TOWN OF DISCOVERY BAY

NOTICE OF THE REGULAR MEETING
OF THE BOARD OF DIRECTORS
OF THE TOWN OF DISCOVERY BAY
October 07, 2026 07:00 PM

G.1 Discussion and Possible Action to (1) Find Anderson Pacific Engineering Construction Not a Responsible Bidder, Reject Its Bid, and Award the Construction Contract to the Next Lowest Responsible Bidder; or (2) Find Anderson Pacific Engineering Construction a Responsible Bidder and Award the Construction Contract to Anderson Pacific Engineering Construction as the Lowest Responsible Bidder, for the Discovery Bay Sewage Treatment Plants 2025 Capital Improvements Project. Page 16

Discovery Bay Sewage Treatment Plants
2025 Capital Improvements Project

JOB NO. 2025-200 T01
DRAWING NO. C-201-A2
SHEET NO. 17 OF 115

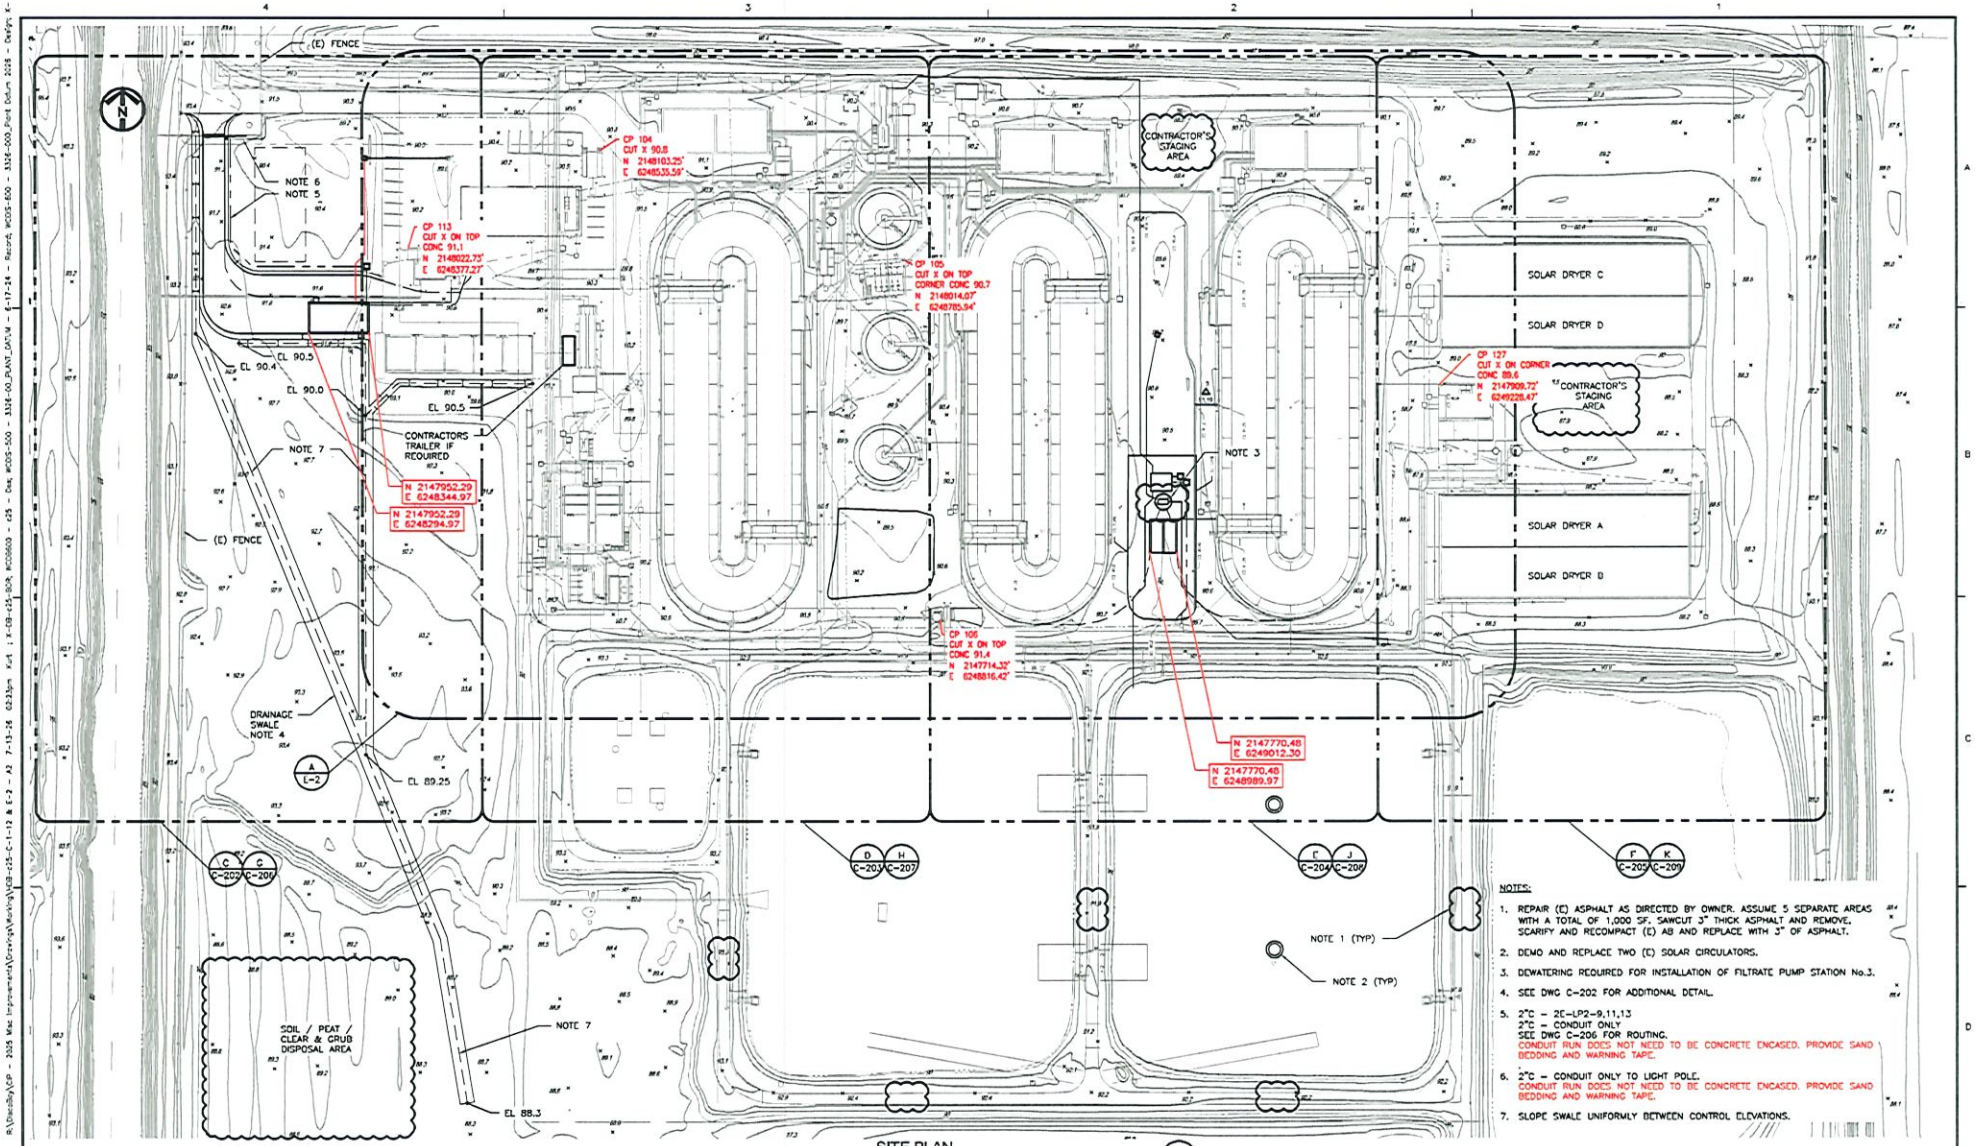
3			Is night work allowed for the work in the Solar Dryers to avoid heat issues?	Night work will be allowed for work directly in the solar dryers only. Contractor shall have a minimum of 2 people on site for this activity. Contractor is responsible for all safety equipment and protocols during all construction and for all night work taking place in the dryers.
4			Can you provide the type of pipe the 1" IA is (on Drawing M-5).	The 1" HPA and 1" IA are called out in the piping schedule as HPA/IA (Specification Section 15052, Page 9).The piping Schedule will be clarified in this Addendum to read HPA & IA. The 3" W referenced in Notes 6 & 12 should be 3" PW as shown on the Plan View. This modification is reflected in this Addendum.
5			Section 01722 Field Engineering does not clarify who is responsible for staking. Is the Town providing this or do we need to include this in our proposal?	The Owner and Engineering are not providing any surveying services on this project. Specification Section 01722 for field engineering describes work to be performed by the Contractor, including all field layout and staking. The only exception is the basic reference line and bench marks provided by the Owner as stated in Specification Section 01722, 1.04.A. We have added existing reference coordinates and bench mark information internal to the plant at several locations to the drawings and provided coordinates of the new structures on the drawings. Contractor is responsible to extend surveying control to your individual work areas and all other survey requirements. See modified Drawing C-201-A2 and C-206-A2 in this Addendum.

DRAWING C-201

1. Replace Drawing C-201 with the attached Drawing C-201-A2.

DRAWING C-206

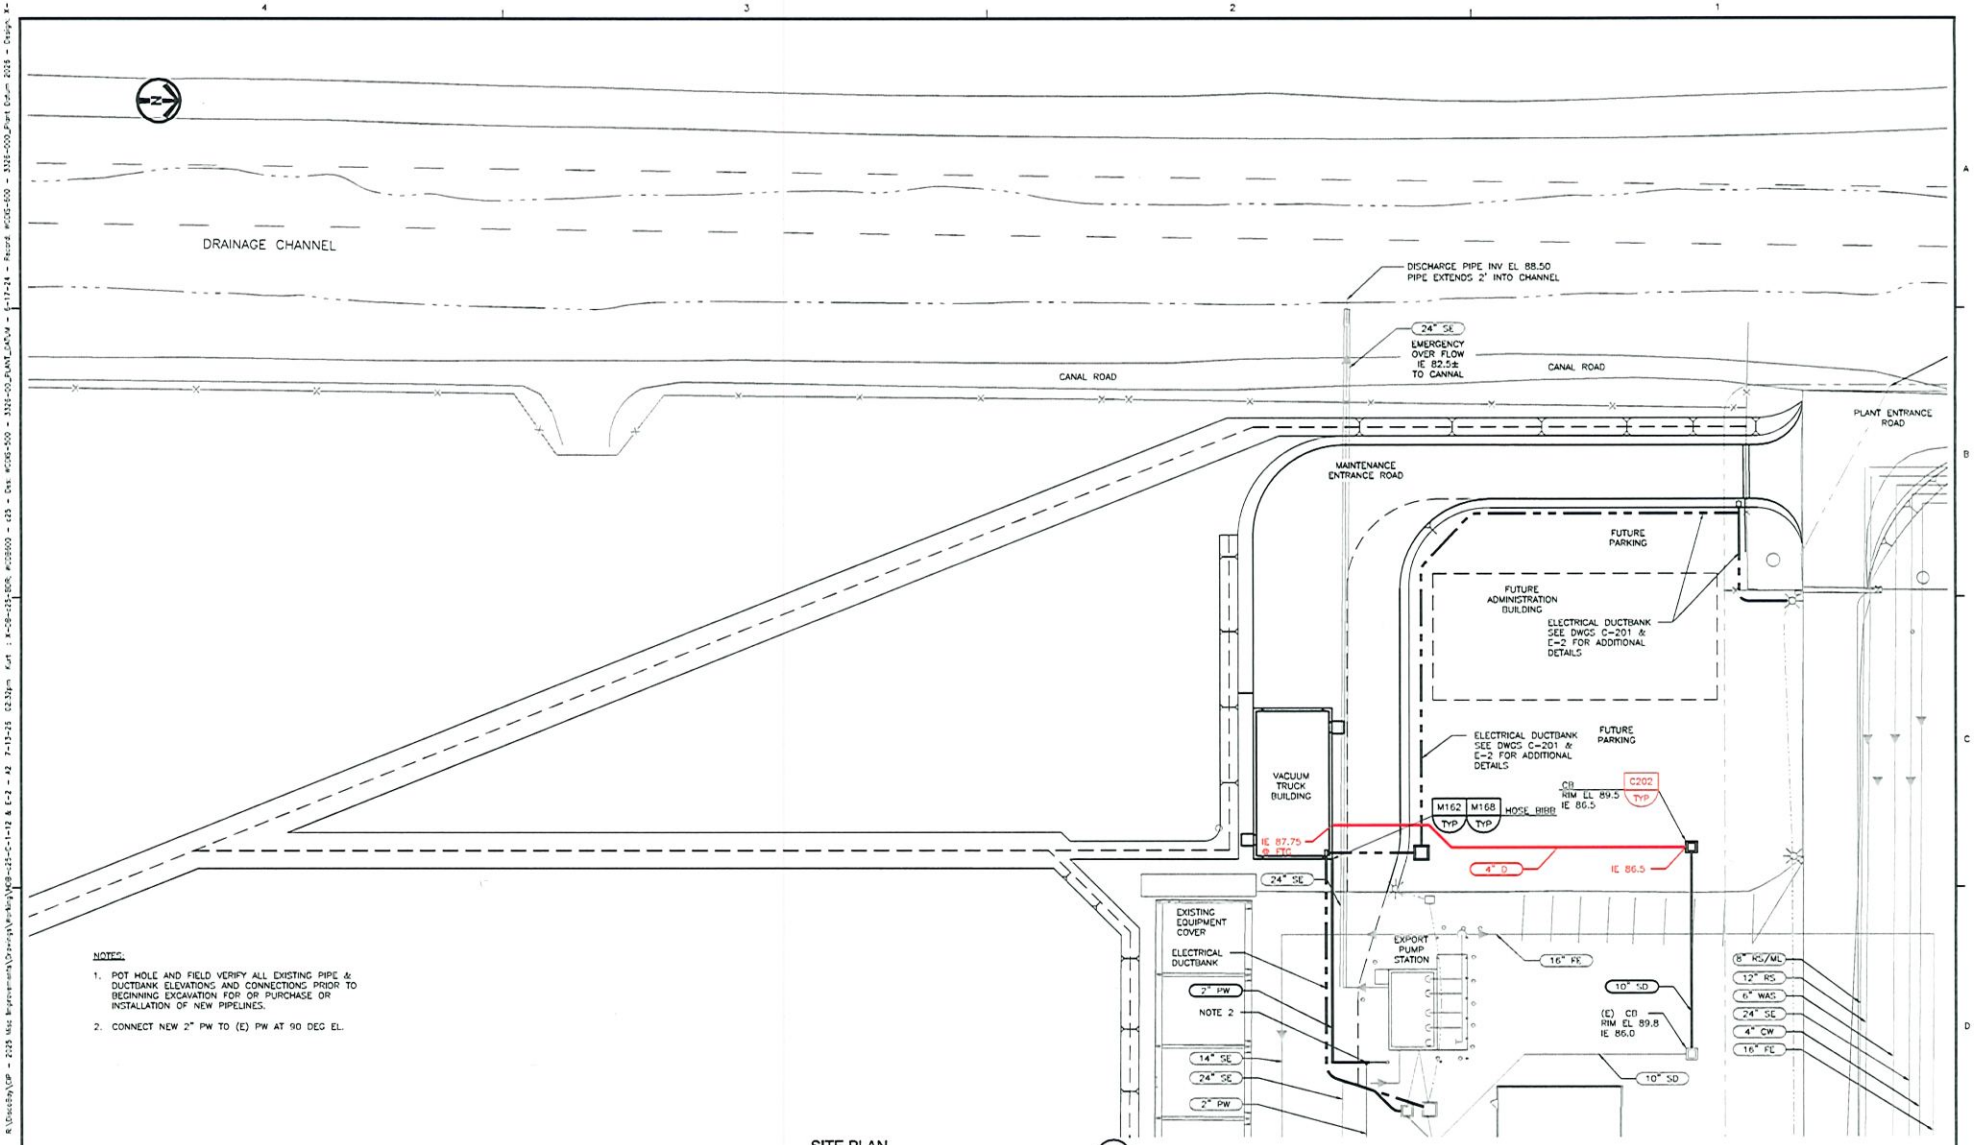
Item No.	Spec Section	Drawing Reference	Question	Response
1			Is there a weight limit above the 24" EFF Pipe shown parallel to the new Vacuum Truck Building on Drawing C-206?	The existing pipe is currently approximately 6 feet below current grade. When the road is excavated for the subbase, the remaining cover will only be approximately 3.5 feet. Heavy crane loads or other point loads should be avoided on top of the pipe once the road section is excavated until AB is placed. Contractor shall locate the Effluent Line prior to construction in this area.
2			Will the Owner mark the utilities prior to construction?	The Engineer will provide copies of existing drawings showing the approximate location of existing utilities. Contractor shall carefully pothole for all existing utilities in work areas Per Section 01140-1.05.C of the project specifications. The Owner will not mark the location of utilities.

Item No.	Spec Section	Drawing Reference	Question	Response
8			I don't see on the plans where the 4" drain ties into outside the Vac Truck Building on sheet S-3. I've looked on the Civil sheets & can't find it.	The 4" D is routed to the Catch Basin North of the building. This information was inadvertently left off Drawing C-206. See modified Drawing C-206-A2 in this Addendum.
9			Is this 14" line new or existing? [at the North West corner of the Drawings C-205 and C-209 running south from the (E) Catch Basin with Text "(E) RIM EL 89.95, IE 85.50)"]	There is no new 14" SD piping on Drawings C-205 or C-209.
10			How much experience in treatment plants is required?	Per specification Section 9 "Bidder's Responsibility Statement" paragraph 2.B, Prospective bidders shall demonstrate a minimum of 5-years experience in constructing projects of a similar size, complexity, and nature for installation of wastewater treatment plant processes and equipment.

5			Sheets S-3 and S-4 indicate a 4-inch underslab drain system; however, Sheet C-206 does not depict the continuation of the associated yard piping. Please provide clarification regarding the proposed routing and the intended point of connection for this line, along with any additional direction necessary for coordination and installation.	This piping was clarified on Drawing C-206-A2 in Addendum No.2.

1. Replace Drawing C-206 with the attached Drawing C-206-A2.

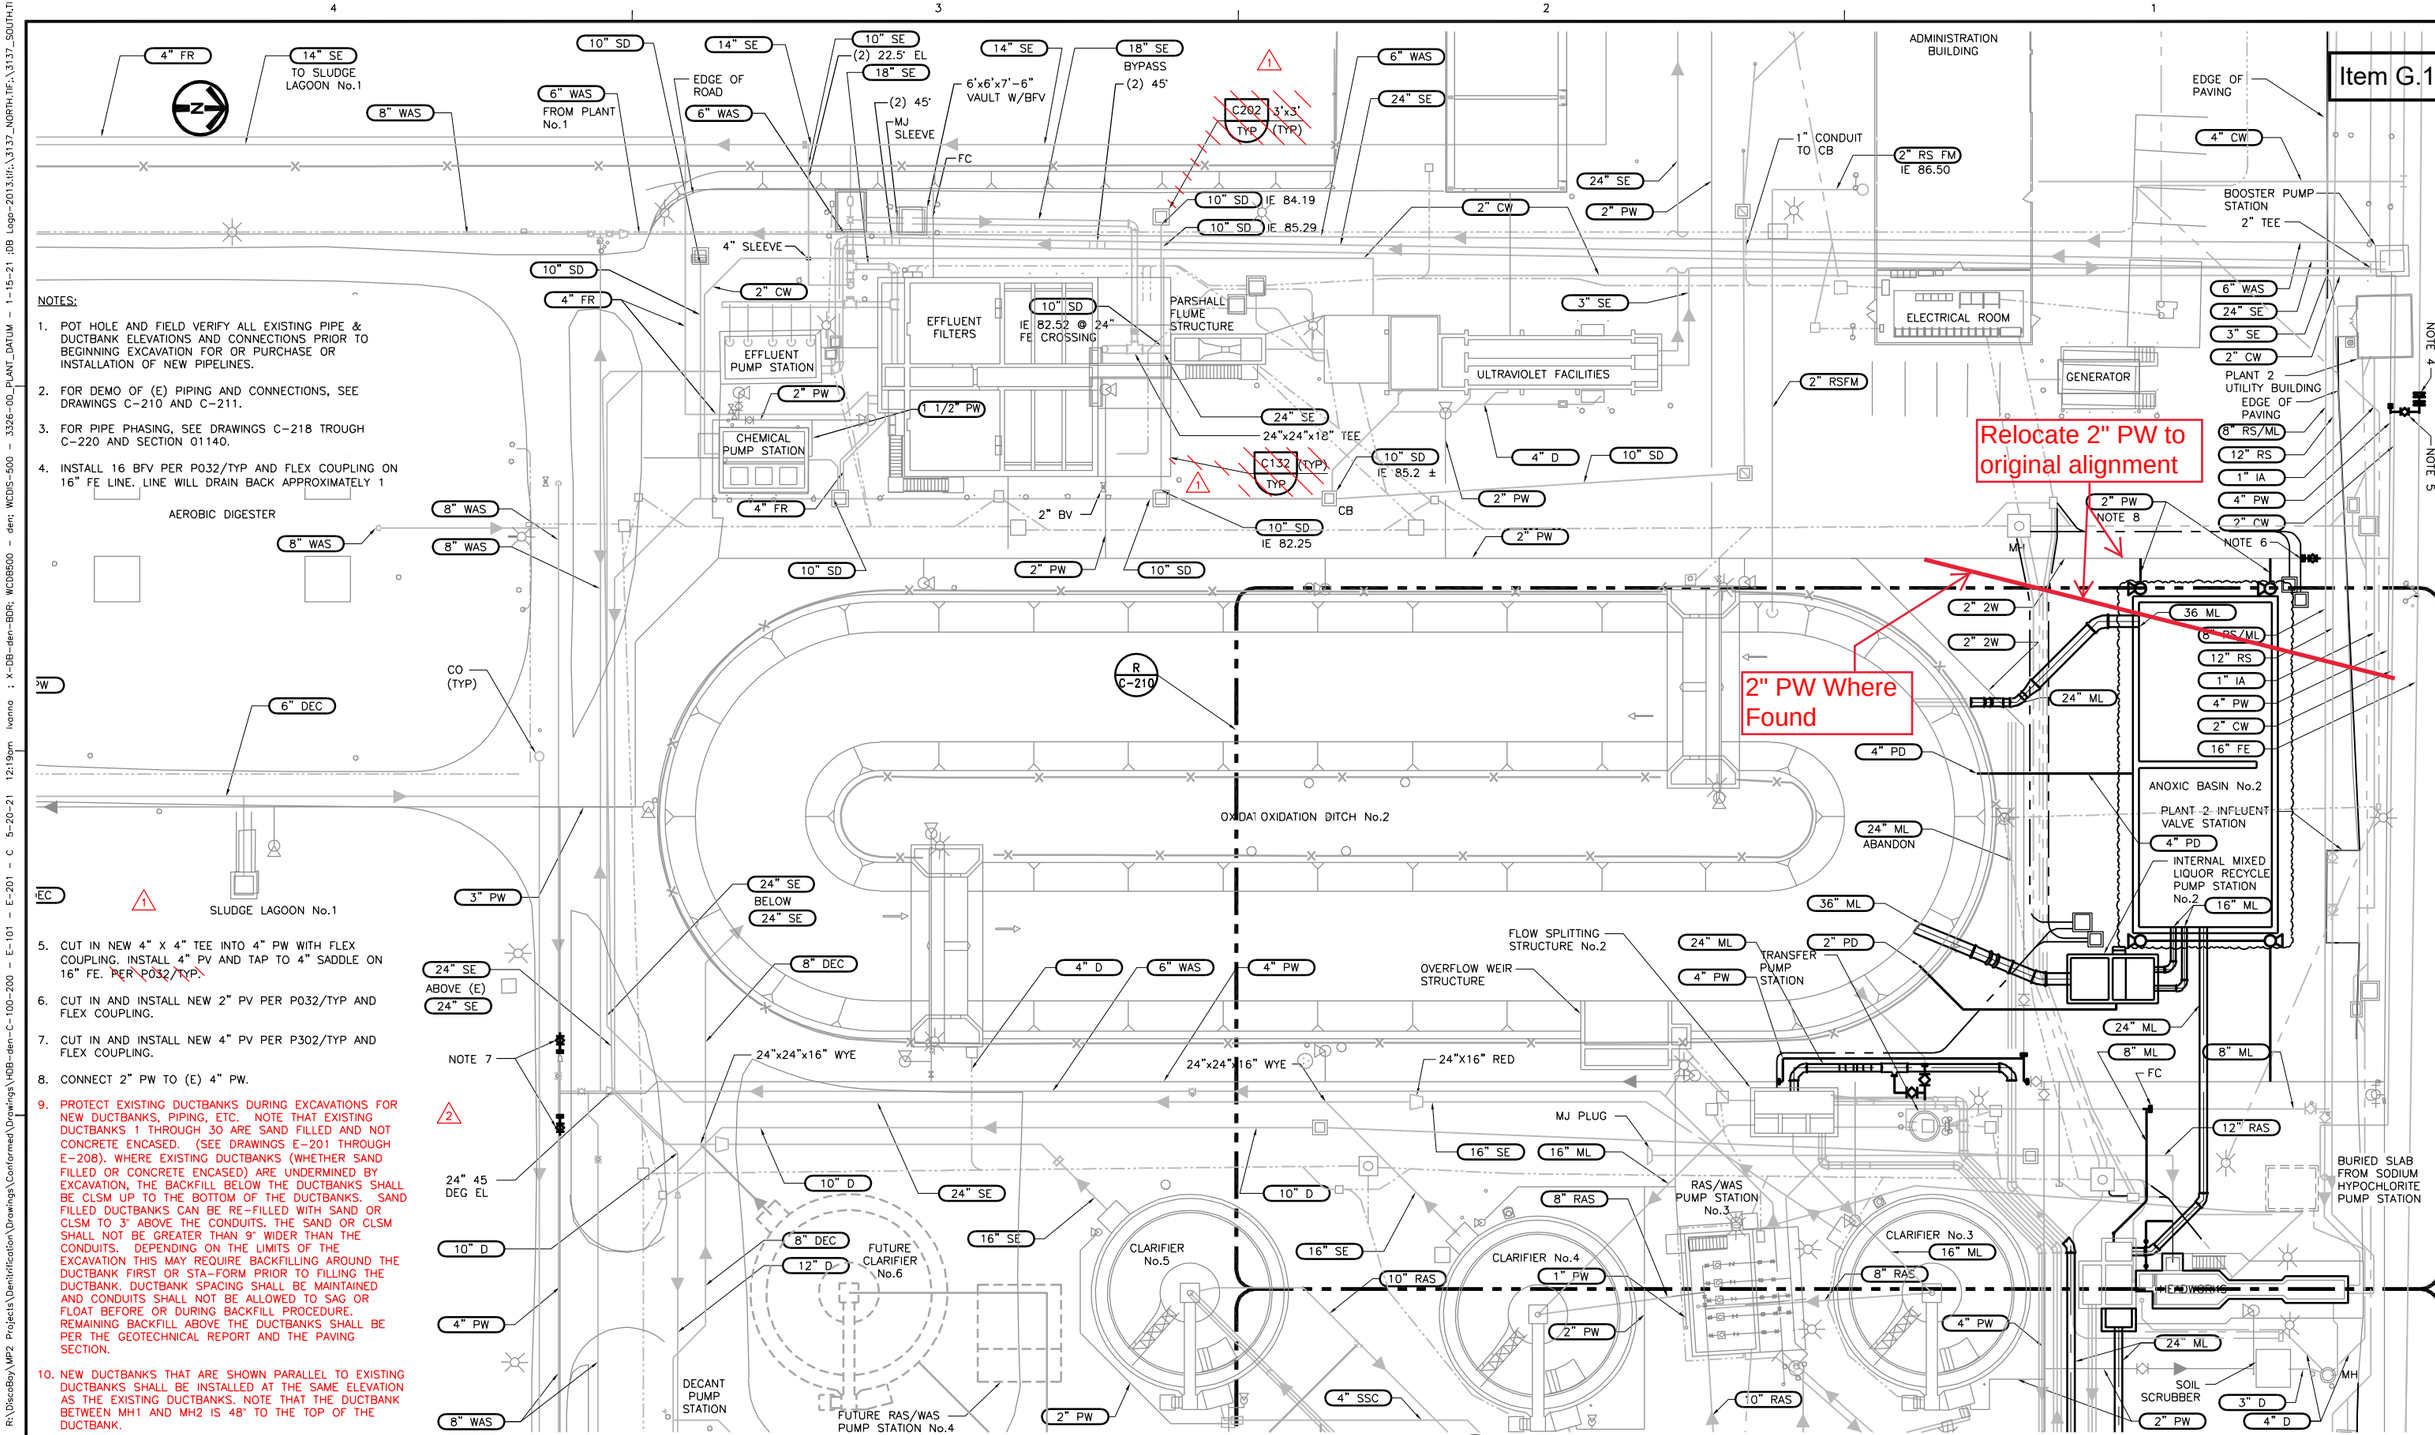
The 2" PW line shown east of Anoxic Basin No.2 on Drawing C-207-C is not located where shown and conflicts with the east side of the structure. Please proceed on T&M to interrupt the 2" PW line on the north and south end of the structure and cap it for now. After construction of Anoxic No. 2 is complete, relocate the line to the east side of Anoxic Basin No. 2 at the location shown on Drawing C-207-C.
